## **Exhibition – Vopak Bulk Liquids Storage Facility, Port Botany (MP 06\_0089 MOD 2)**

# Review of MP 06\_0089 MOD 2

## Vopak Site B Capacity Increase

For Bayside Council (East)

**Figure 2: Comparison of QRA worst case tank overfill dispersion results and UK HSE LSPSS Outer Zone**

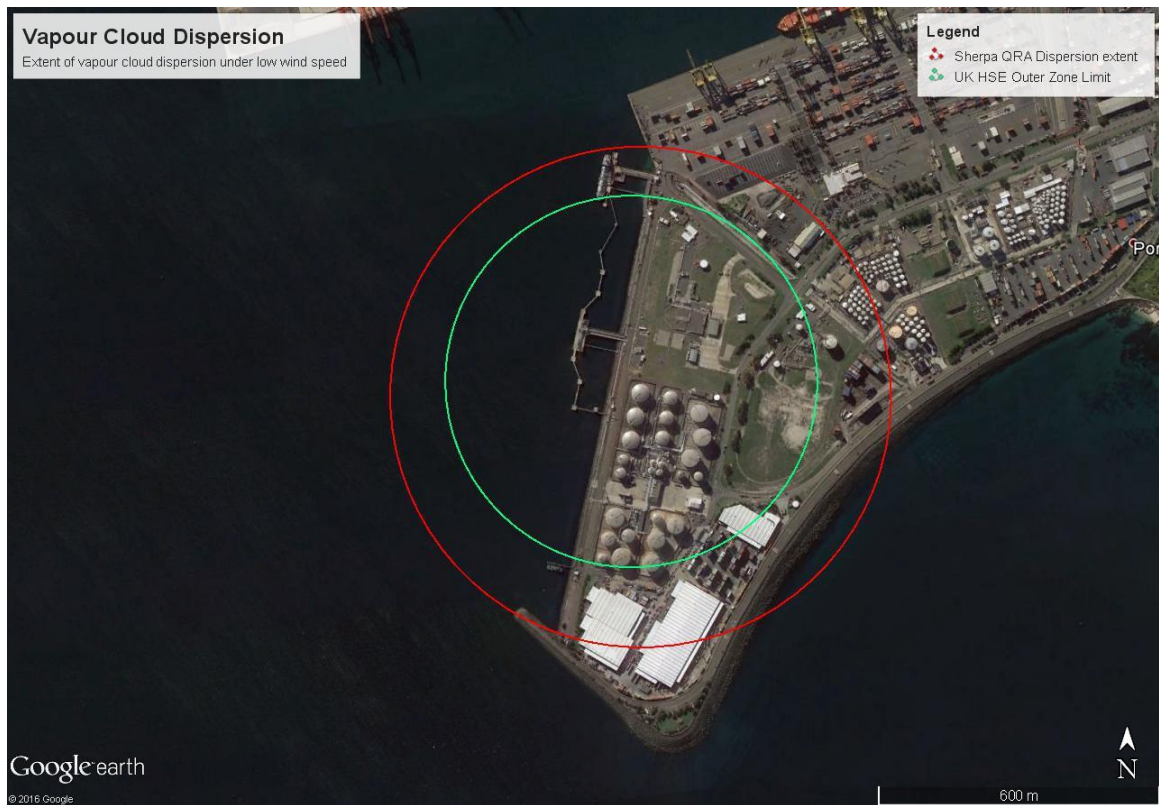
Figure 2 shows the comparison between the dispersion results for Vopak and the UK HSE Outer Zone that would have been applied to a LSPSS in the UK. The calculated dispersion distance extends beyond the outer zone, indicating the calculation is suitably conservative. Neither the calculated vapour cloud nor the Outer Zone distance encroach the boundary of any Bayside precincts.

Arriscar used information directly from the UK HSE Contract Research Report 908 [12] and process data from Appendix D [8] to confirm the modelling of Sherpa. Calculations are provided in Appendix I of this report. While it is not clear what process temperature was used in the Sherpa modelling, at 28°C Arriscar found the flammable cloud could extend 539 m. This also confirms reasonable modelling of the gas cloud.

Figure 5: Individual Fatality Risk Results for the Vopak 2023 Case, from all DG movements [10]

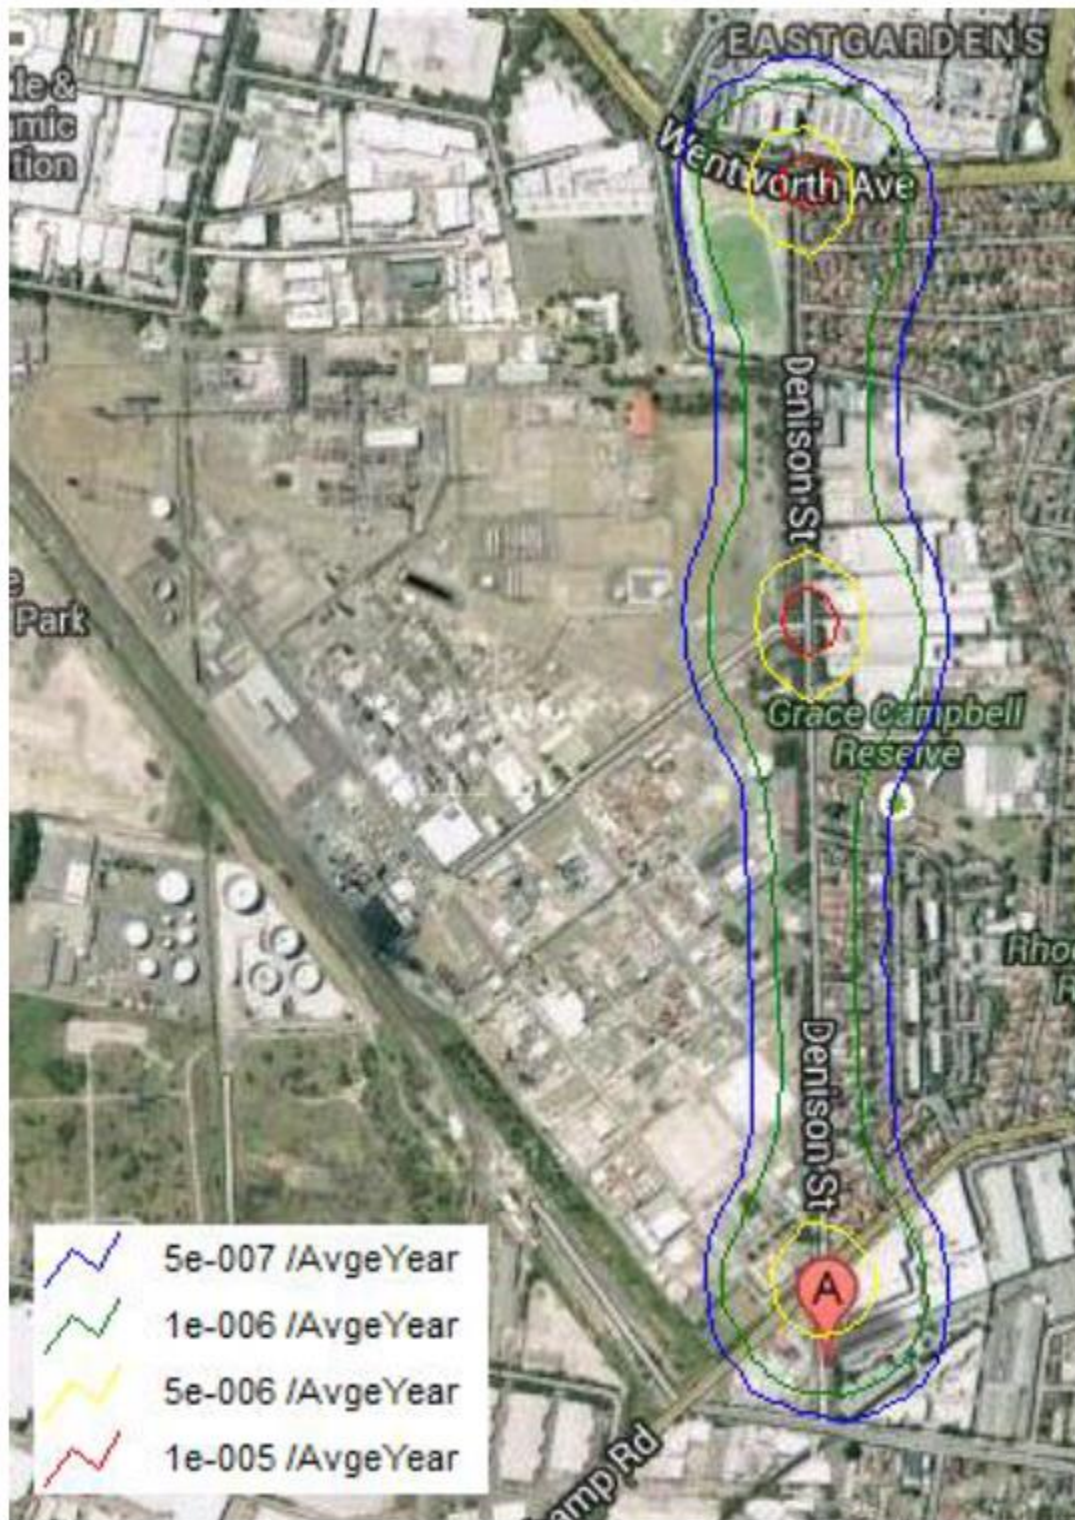
The individual risk at different stages, and for both all DG traffic, and limited to VOPAK traffic only is presented in [10]. The individual fatality risk results for existing movements and the 2023 case, as shown in [10] are presented in Figure 4, Figure 5 and Figure 6. The following findings may be drawn:

- The existing individual risk from all DG movements exceeds the residential individual fatality risk criterion provided in HIPAP No. 4 [13]. Individual fatality risk levels in residential areas to the south near Beauchamp Road and north near Wentworth Avenue exceed  $1 \times 10^{-6}$  p.a.
- In 2023, the residential land use individual risk criterion is exceeded on the same basis as above.
- Vopak traffic alone (total Vopak movements in 2023) does not exceed the criteria set out in [13]. Furthermore, as Vopak traffic forms the majority of Class 3 (Flammable Liquids) movements in Denison Street, the majority of risk must be generated by other DG Classes, namely Class 2.1 (Flammable Gases), and Class 2.3 (Toxic Gases). This is explained by the typically greater consequence distances for the latter two DG scenarios as compared to Class 3 fires.

**Figure 8: FN Curve for all DG movements on Denison St [10]**

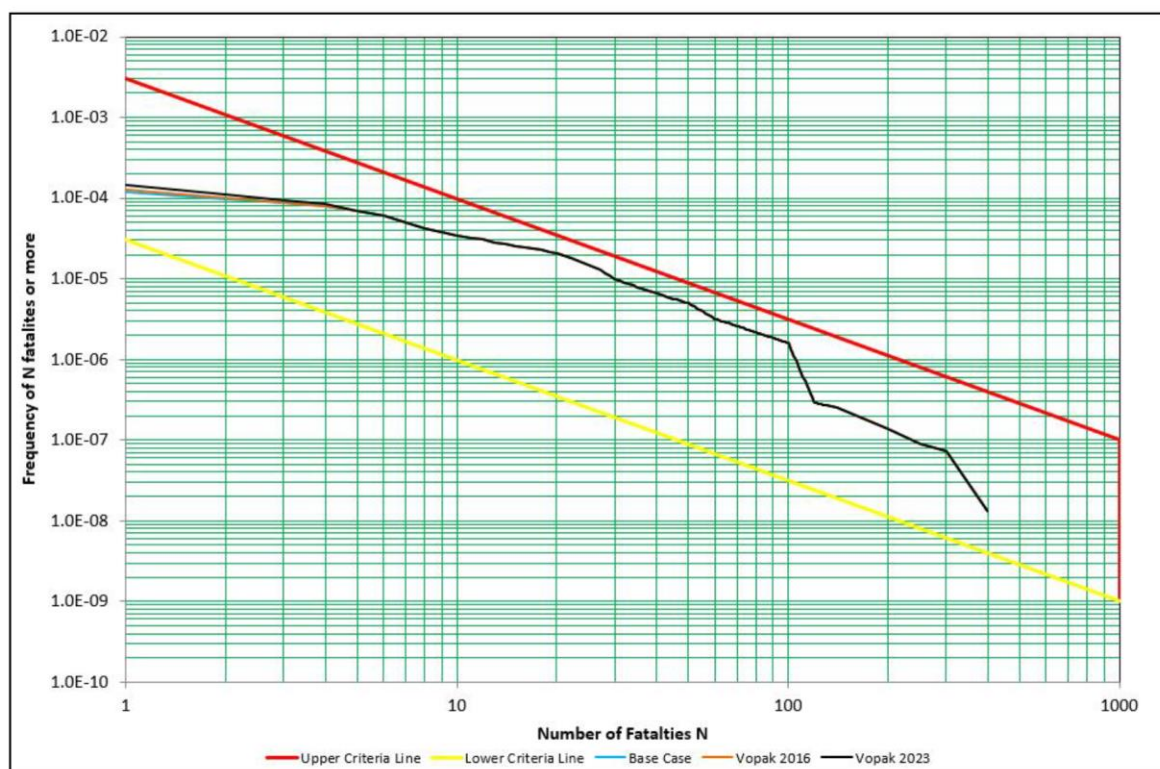
Figure 8 shows societal risk for all DG movements along Denison Street, and confirms the conclusion drawn from Figure 7. Above N= 4 fatalities, the increase in societal risk due to the increase in Vopak movements is barely appreciable.

Table 1 lists the captions from F-N curves submitted in Appendix F [10]. From the captions of each figure, it is unclear if the contribution of risk from nearby fixed facilities such as the Botany Industrial Park (BIP) has been included in these results. As such, the EA has not addressed item 7.2.4 c) from the Review of Planning Controls [1] .
